1 Q. At page 7 of Hydro's Report in support of its Application, Hydro relates that the
 2 "impedance mismatch" outlined therein results in a "loss" of transformer capacity
 3 in the magnitude of 31.8 MVA.

Figure 1: Hardwoods Maximum Transformer Loading

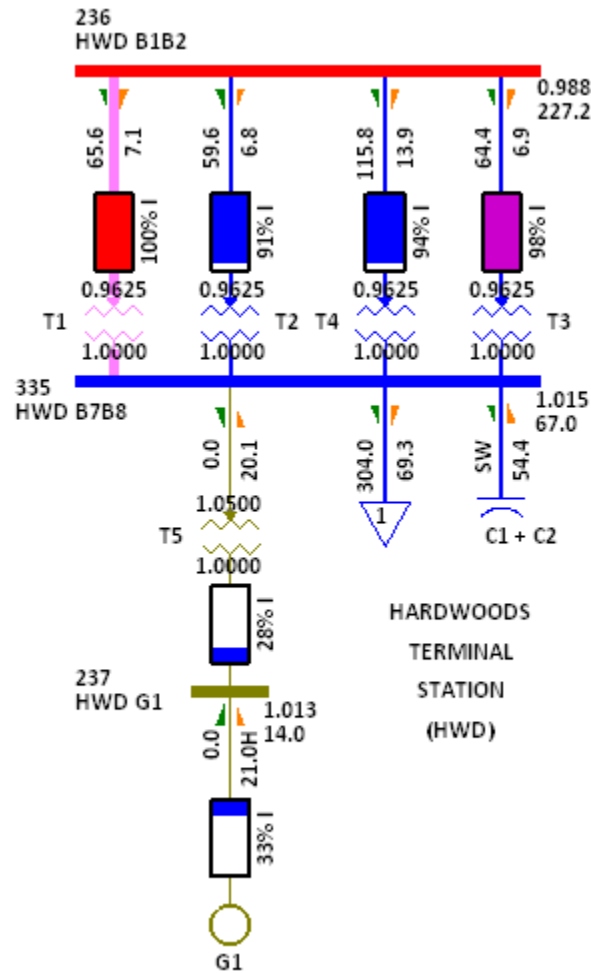
4
 5 (i) Please explain how such capacity is "lost" and whether there are
 6 alternatives available to recapture such "lost" capacity in the loop short of
 7 installing a new transformer?; and

12
13 If one considers the transformers in the Hardwoods Terminal Station and
14 ignores the effects of the connected 66 kV transmission system and the
15 Oxen Pond transformers, Hardwoods T1 is expected to reach 100% of its
16 nameplate rating before T2 through T4. A simple load flow case with the 66
17 kV transmission disconnected and all the load being carried on the
18 Hardwoods 66 kV bus, provides an example of the effects of impedance
19 mismatch on station loading. Figure 1 provides a load flow plot of the
20 Hardwoods Terminal Station with 304 MW of load on the 66 kV bus. One
21 will note that transformer T1 is loaded to 100% of its nameplate rating,
22 while T2, T3 and T4 are loaded to 91%, 98% and 94% of their nameplate
23 ratings respectively. This mismatch in impedances results in approximately
24 16.8 MVA of transformer capacity being unavailable. Increasing the load on
25 the Hardwoods 66 kV bus will result in the loading on T1 exceeding 100% of

26 its nameplate rating before the remaining transformers reach 100% of
27 rating.
